PRODUCT INFORMATION BULLETIN

Bulletin Number : PIB-01-2026 Rev. 1

Subject : Vigil Cutter Service Life

Vigil Cutter DOM MM/YY

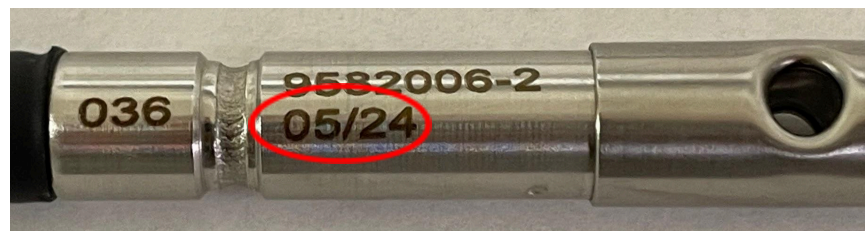
For **Vigil II** AADs, if the DOM of the cutter is more than 6 months prior to the DOM of the Vigil unit, the complete Vigil unit should be sent back to the factory for servicing and or cutter replacement before the end of the service life of the cutter is reached.

For **Vigil 2+** AADs, the cutter may be replaced in the field.

Moving forward, when replacing cutters in the field, to avoid potential situations where the cutter service life of the replacement cutter may exceed the service life of the Vigil unit, it is highly recommended that the replacement cutters not be more than 6 months older than the DOM of the Vigil unit. If older cutters are used, in addition to tracking the DOM of the Vigil unit, the DOM of the cutter must also be tracked to ensure that it does not become unusable because it has reached the end of its expected service life.

For units that have a cutter that is more than 6 months older than the Vigil unit, but are due for battery service prior to the end of the service life of the cutter, the cutter will be replaced at the time battery service is performed.
